# **Final Environmental Impact Report**

**Chapter 7 – Response to Comments**

### **SANDRINI SOLAR PROJECT**

**RE: Response to Comments for Draft Environmental Impact Report – Sandrini Solar Project by  
EDPR CA Solar Park (EDP Renewables, LLC) (SCH #2021040761)**

**FIGURE 3-8**  
**Williamson Act - Active and Nonrenewals**  
 Kern County Planning and Natural Resources Department  
 Sandrini Solar Project f By: EDP Renewables North America, LLC

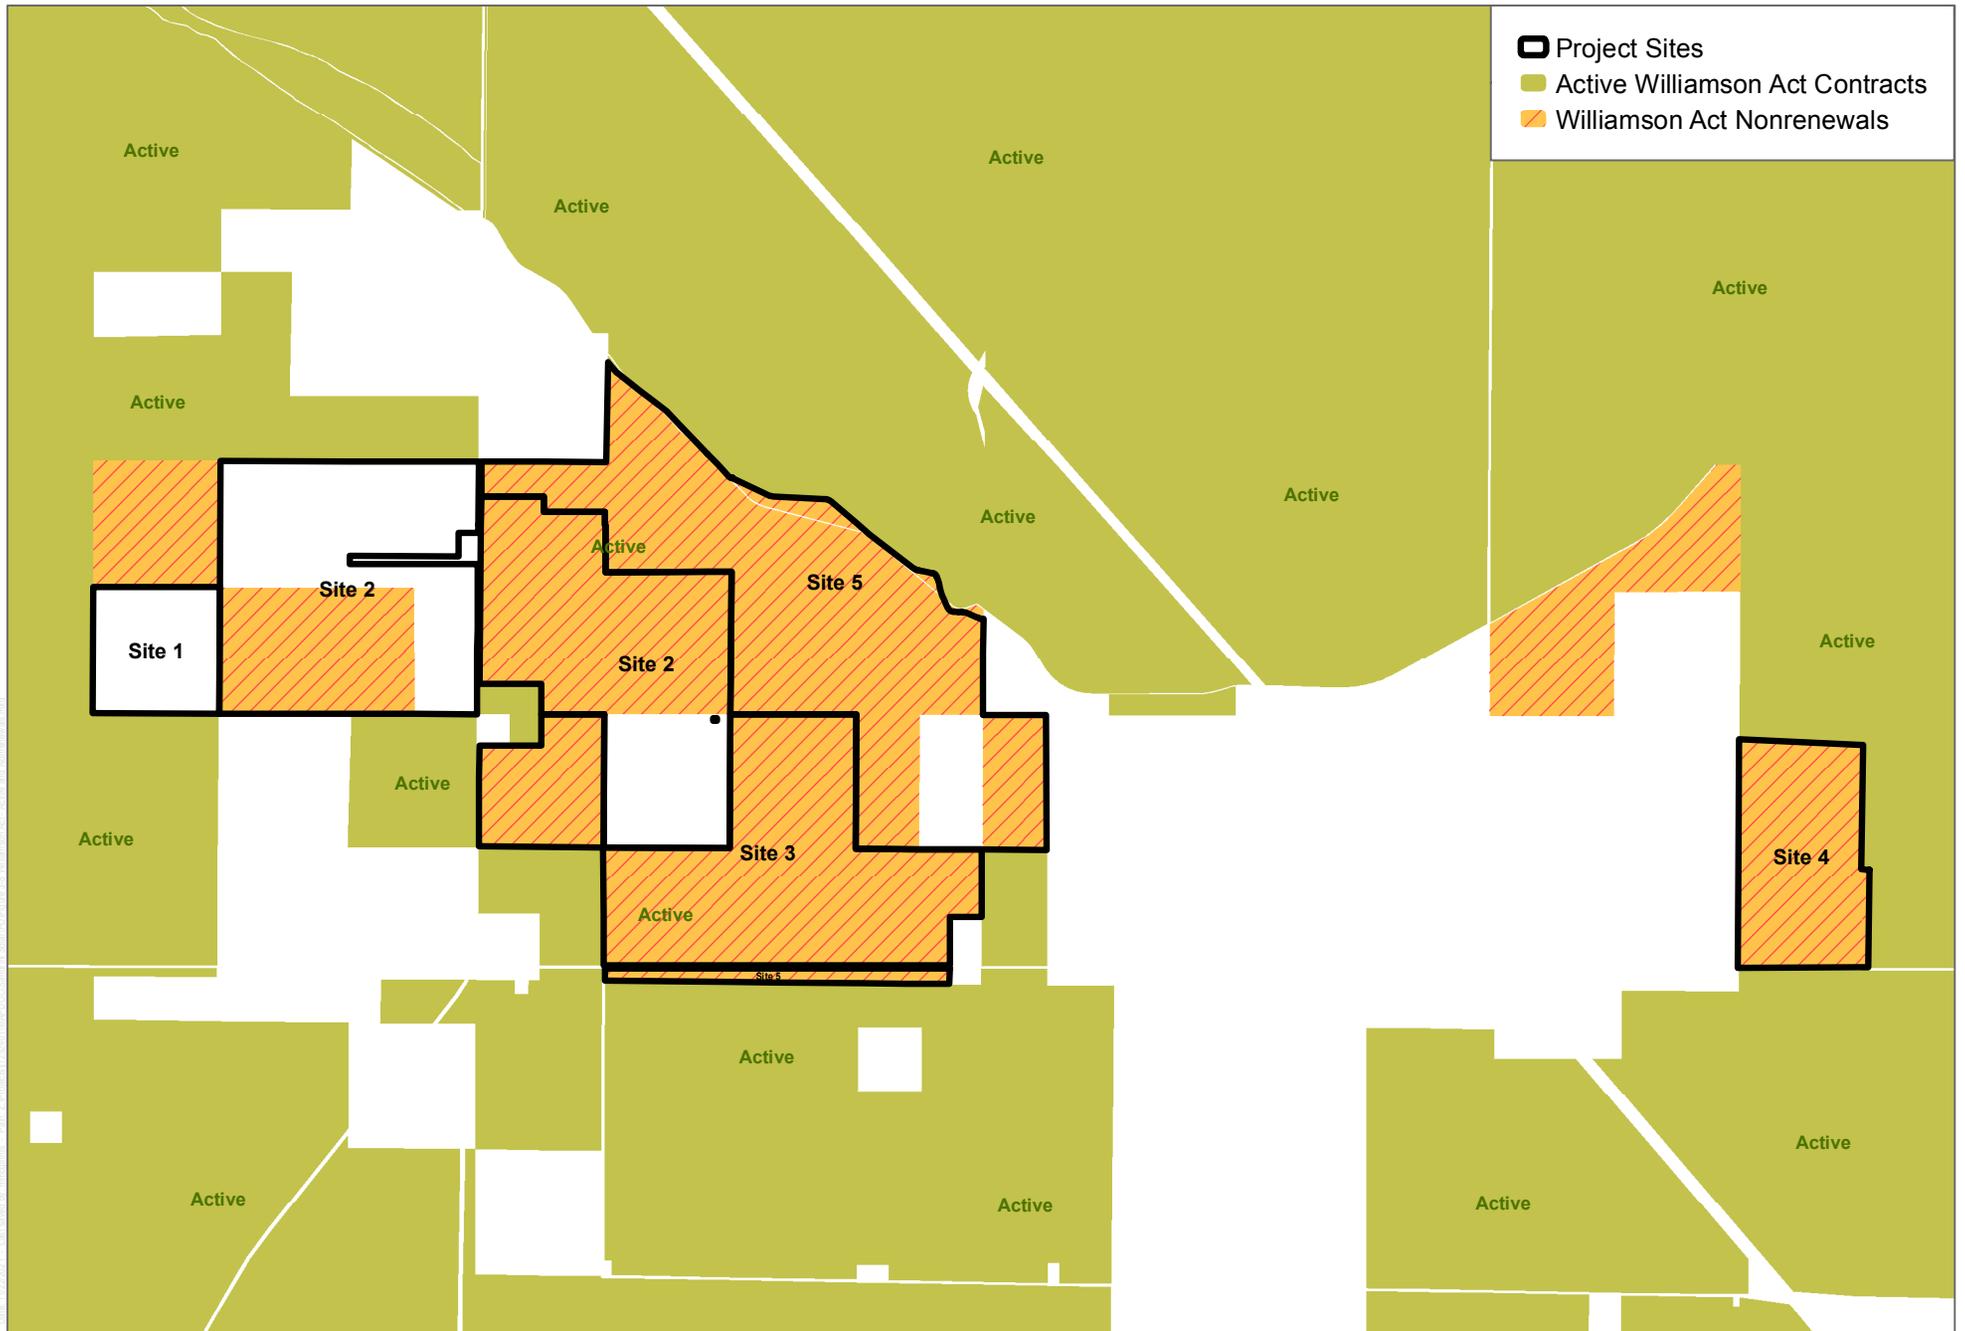
Figure 3-8 revised to show that all Williamson Act contracts for parcels located within the project boundary are in non-renewal status.
